LIBNA FAULT

**RESPONSE TO
IRSN/DIR/2013-00010**

PROJECT NO. 12-4835
15 FEBRUARY 2013

**FIGURE 1-1
LIDAR IMAGE- LIBNA HILL**

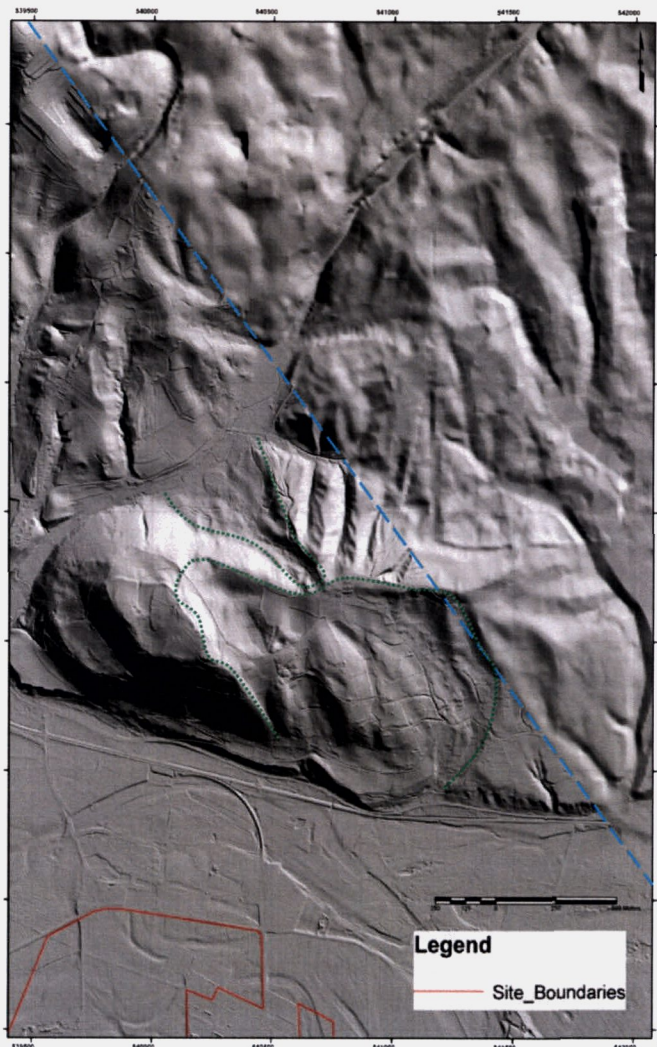
IRSN Statement No. 1: The Libna Fault outcrops “a short distance from the Krško II sites” and is “located at only a few hundred meters from these sites.”

Response No. 1: There is no professional consensus that the Libna fault “outcrops” on Libna Hill. Lacking further information from IRSN, it is assumed that IRSN is referring to the NE facing escarpment on Libna Hill (not an outcrop). From a gross geomorphic perspective, the “outcropping” of the Libna Fault is a reasonable, simplified, first-order interpretation; however, more careful investigation indicates that the landform in question is a response to multiple processes that are dominantly controlled by mass wasting-related processes.

Recent research based on an extremely high-resolution 1.0 meter (m) digital elevation model (DEM) derived from light detection and ranging (LiDAR) has indicated several complex processes that are responsible for shaping the current surfaces of Libna Hill. Please refer to *Figure 1-1*.
